ND-2012-0059 October 3, 2012

Subject: PSEG Early Site Permit Application Docket No. 52-043 Response to Request for Additional Information, No. Env-14, ESP EIS 9.0 – Environmental Impacts of Alternatives

RESPONSE to RAI No. Env-14

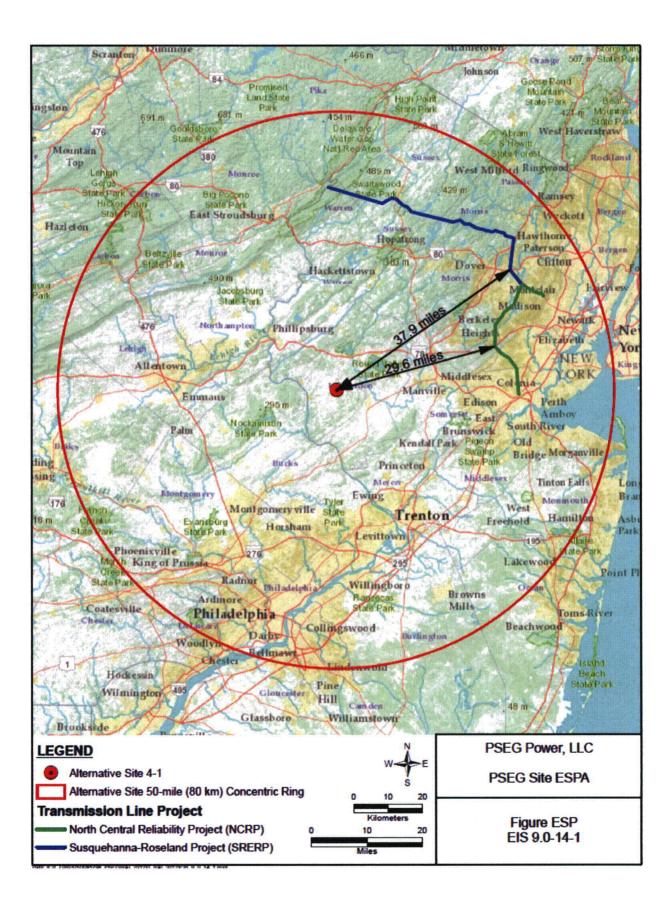
rALT-38: Provide an analysis to describe how, if at all, PSE&G's North Central Reliability Project and the proposed Susquehanna-Roseland Power Line Project would change the potential environmental impacts described in ER Section 9.3.2.1 for Alternative Site 4-1 in Hunterdon County, New Jersey.

Provide a discussion of the potential impacts and implications for Alternative Site 4-1 that would be associated with PSE&G's North Central Reliability Project to be constructed in New Jersey through West Orange, Livingston, Roseland, Florham Park, Chatam Borough, Chatam Township, New Providence, Berkeley Heights, Watchung, Scotch Plains, Fanwood, Clark, Edison, Metuchen and Woodbridge.

Also, provide a discussion of the potential impacts and implications for Alternative Site 4-1 of the proposed Susquehanna-Roseland Power Line Project, which would connect Berwick, Pennsylvania, to Roseland, New Jersey.

The closest part of the NCRP is approximately 30 miles from the Hunterdon site (Site 4-1) (Figure ESP EIS 9.0-14-1). This project has already begun pre-construction and construction work in the right of way and the upgrade is scheduled to be in-service by June 2014. Although an ESP does not constitute a decision or approval to build new units, site preparation activities and construction of the proposed causeway (i.e., preconstruction activities) are scheduled to begin in 2015, whereas construction activities for the new plant are scheduled to begin in 2016. PSEG's response to RAIs rGEN-04 and rGEN-05 in ENV-01 provides clarification as to preconstruction and construction activities, such site preparation activities will take 12 to 36 months to complete. New plant construction occurs over an additional 5-7 year period. In consideration of the large temporal space between these projects, cumulative impacts due to construction will be minimal.

The closest point of the SRERP is 38 miles away from Site 4-1 (Figure ESP EIS 9.0-14-1). Site preparation and construction activities have already begun and the project is expected to be in-service by June 2015. As described above, construction of the PSEG Site occurs over a long period of time beginning in 2016. In consideration of the large temporal space between these projects, cumulative impacts due to construction are minimal. As with the NCRP, SRERP transmission lines are constructed primarily within existing rights of way. Consequently impacts associated with land use alteration, wetland conversion, visual impacts and habitat fragmentation are minimized. Therefore, the construction and operation of the SRERP does not have the potential for additional cumulative impacts relative to those assessed for Site 4-1.

However, unlike the NCRP, the SRERP provides substantial synchronizing energy into that part of NJ, such that it will negate the need for an additional stability line for Site 4-1. Comprehensive stability studies by PJM are required to determine the scope of transmission upgrades necessary to accommodate a new plant. ER Subsection 9.3.2.1.1 states that the land use impact of transmission for Site 4-1 is MODERATE, primarily due to the construction of the transmission line to the Peach Bottom substation for regional stability. If formal PJM impact studies determine that such a line is not needed, the impact will be reduced from MODERATE to SMALL. While this will make Site 4-1 somewhat more desirable than shown in the ER, Site 4-1 is still less desirable than the Proposed Site with regard to several other types of impacts (see ER Tables 9.3-22 and 9.3-23).

PSE&G's North Central Reliability Project does not change the potential environmental impacts described in the ER Subsection 9.3.2.1 for Site 4-1. However, because of the potential effect of providing regional transmission stability, the proposed Susquehanna-Roseland Power Line Project may reduce the potential transmission-related environmental impacts.
